# Annex I

## Environmental Impact Assessment

### Schedule III

**ERA Reference no.:** EA/00027/19  
**PA Reference no.:** PA/04647/18  
**Project Title:** Landscaping works including alterations to carriageway, construction of promenade, installation of infrastructural services, paving works, installation of street furniture and provision of parking spaces.  
**Location:** Site at, Triq Tat-Tabija/, Triq Gheriexem, Rabat, Malta  
**Screening date:** May 2019

**Figure 3:** Photomontages (Source: PA/04647/18/Doc.1357a-b)

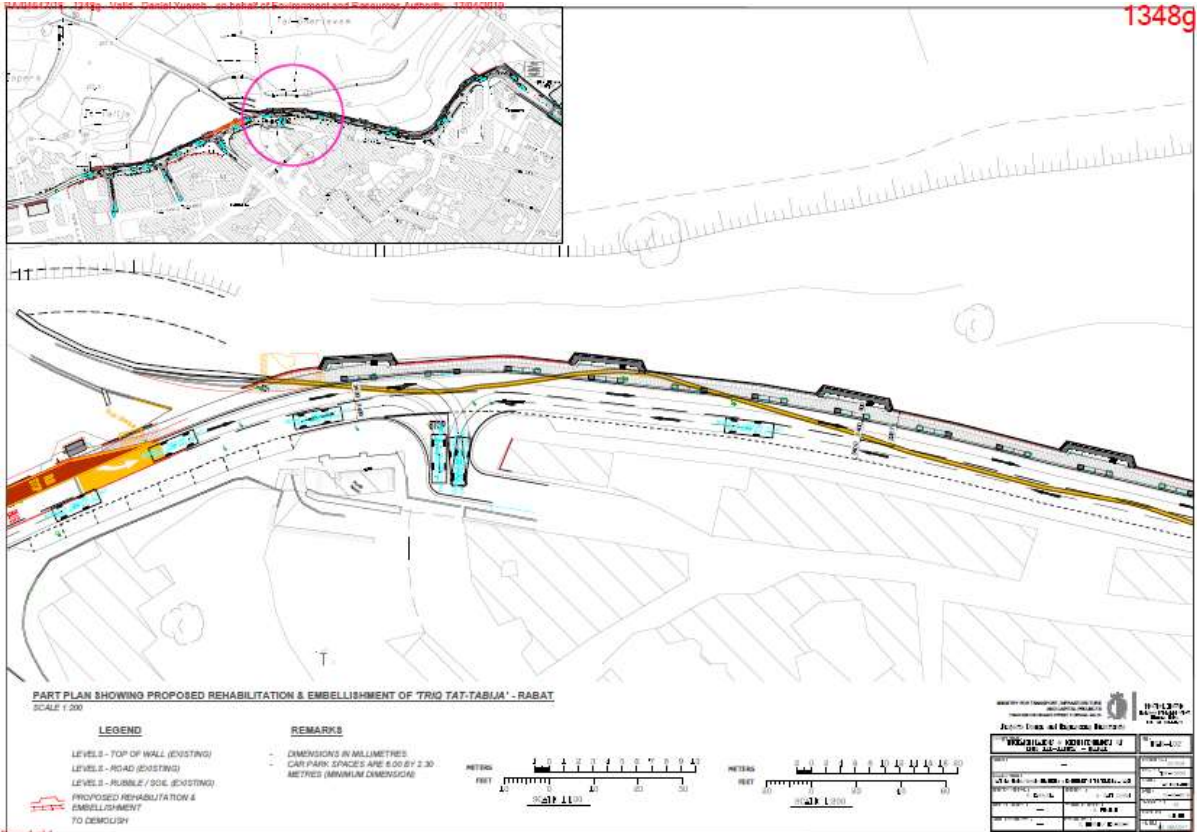
- 3.13 The proposed project is located on the edge of Rabat facing Mtarfa which will involve infringement into undeveloped land in the valley that will affect two Areas of High Landscape Value. The eastern side of the project within the Rabat and Mdina area is designated as an Area of High Landscape Value as per Government Notice 348/01. The western side of the project partially falls within the Mdina Area of High Landscape Value as per Government Notice 1064/13. The project is unlikely to have any significant impacts from long-distance views as can be noted from the photomontages at Figure 3. Short-distance views are deemed significant.

- iii. *Landscape and visual amenity*: Whilst the photomontages indicate that the proposed intervention is not conspicuously visible from the selected long-distance views, impact from closer-range viewpoints is expected to be more pronounced. This issue needs to be addressed through the following:

- Inclusion of other representative receptor points (see approximate indications in the attachment); and
    - Efforts for exhaustive mitigation of visual impact on the immediate and pristine rural environment (short-distance views), such that the development blends harmoniously into the surrounding landscape backdrop (interface between historic/urban and rural environments). A clear indication of the design measures that will be adopted in this regard is required.

- i. Photomontages taken from the viewpoints attached to this reply;
- ii. A rendered elevation to mitigate the visual impact of the proposal;
- iii. A plan showing an overlay of the piles such that the species identified at Figure 4 (below) are unaffected; and
- iv. Sections showed on doc 1348d are to be cross-referred on the respective plans in docs 1339 b to e and docs 1348 e to h, and the carriageway and promenade width should be minimised so as to address the concern that had already been indicated by ERA.

**Figure 4:** Ecology Survey

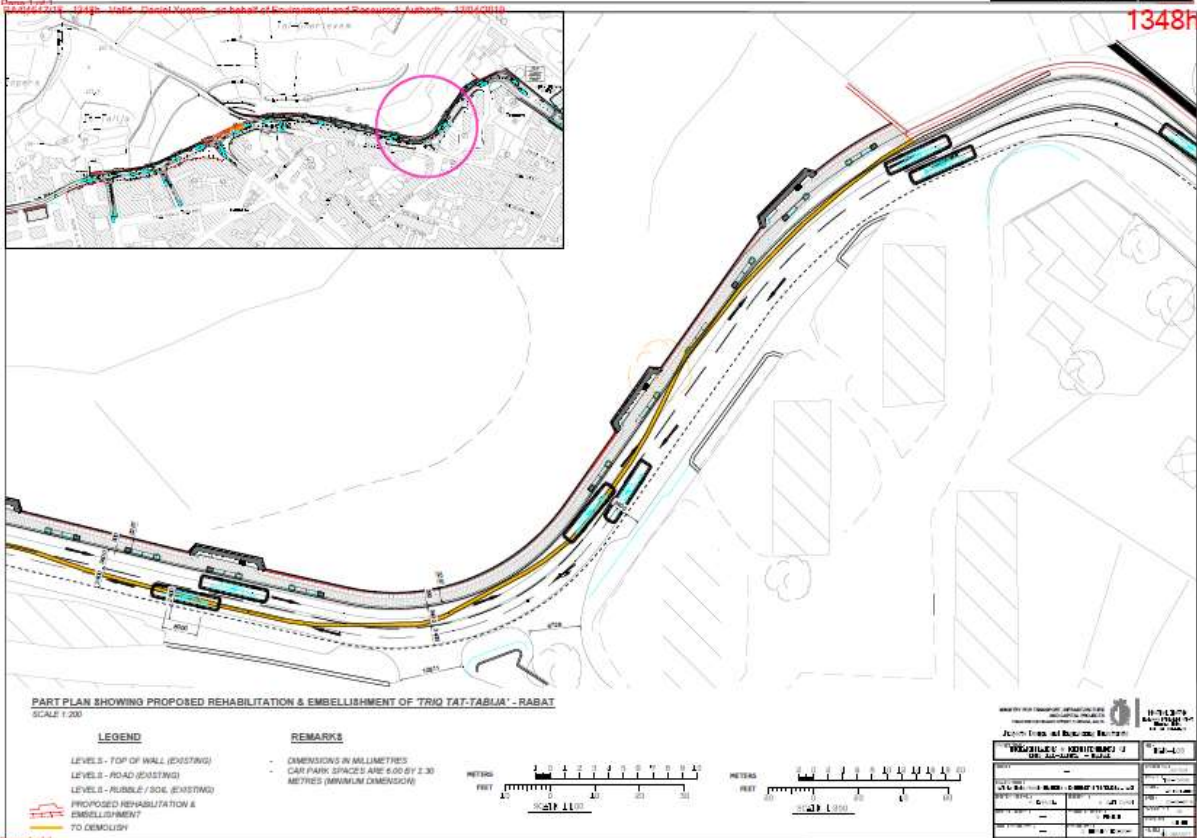
- iv. *Ecology*: The continued existence of existing features worthy of conservation (e.g. aquatic vegetation; unique large Fig tree *Ficus carica* – see attached vegetation survey) needs to be guaranteed and integrated into the project design.
